Appendix B – Statement of Conformity Reviews

**Proposed Section 73 Application to Vary Condition 4 of Outline Planning Consent 17/02534/OUT – ES Chapter 6**

With regards to the Section 73 Application referenced above, relating to a change in the overall height of the buildings, which will form part of the development. We have reviewed the Environmental Statement which was included in the original outline planning consent (titled “Bicester Office Park, Environmental Impact Assessment Volume 1: Environmental Statement” dated December 2017), specifically the chapters which are relevant to our services on the development – “Chapter 6 Socio-Economics”.

Figure 1 - Amended parameter plan

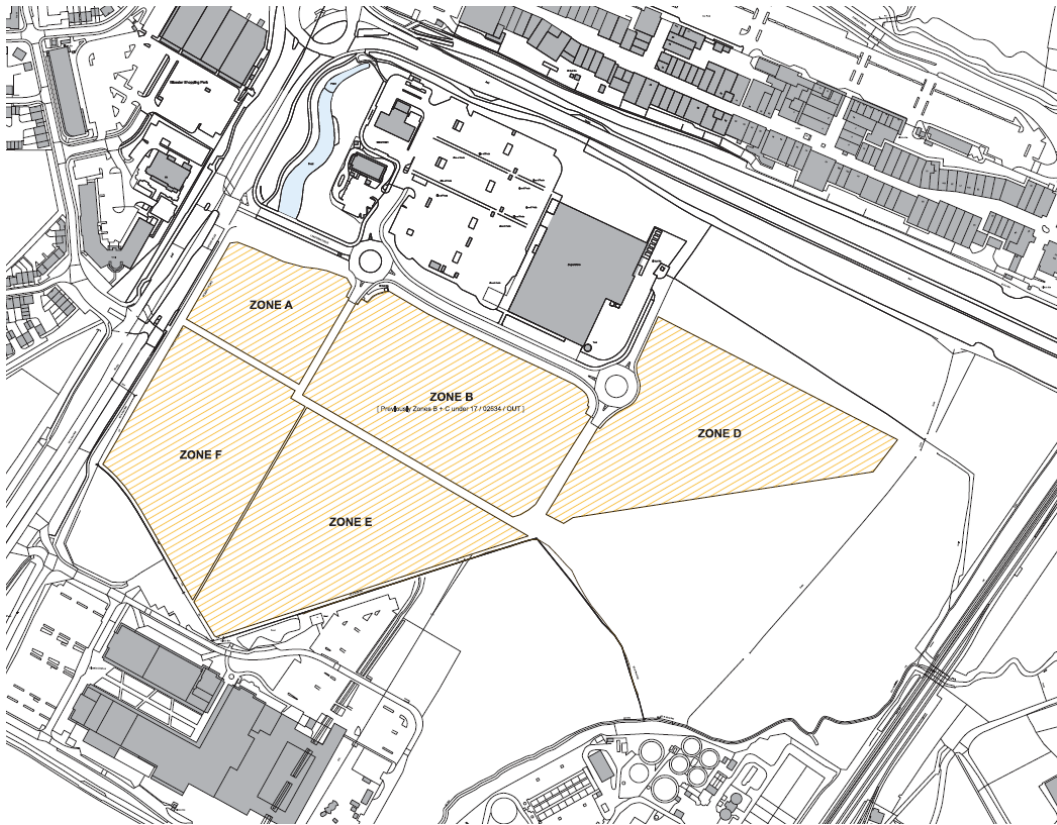
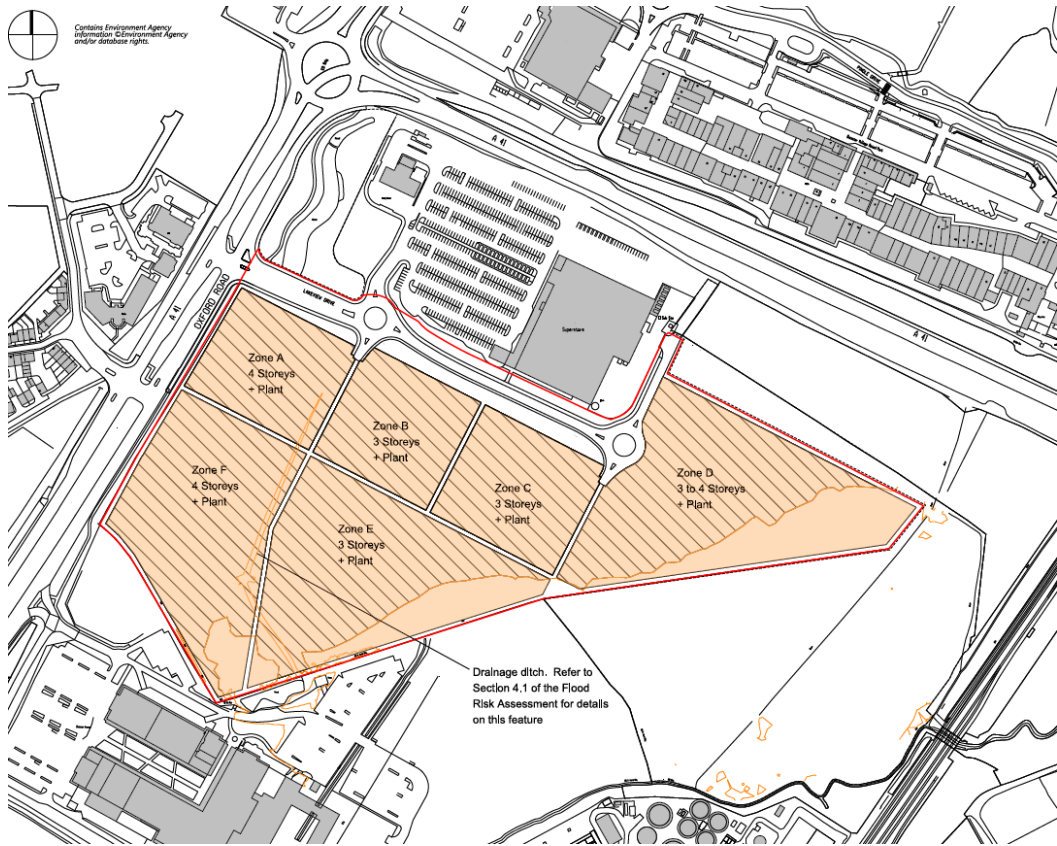
The parameter plan (Figure 1) illustrates the amended developable areas, which are considered against the consented outline application 17/02534/OUT (Figure 2). The maximum development height for each zone is also amended as illustrated in Table 1. Overall, the new proposal adds between circa 2m and 5.5m AOD to the approved outline application.
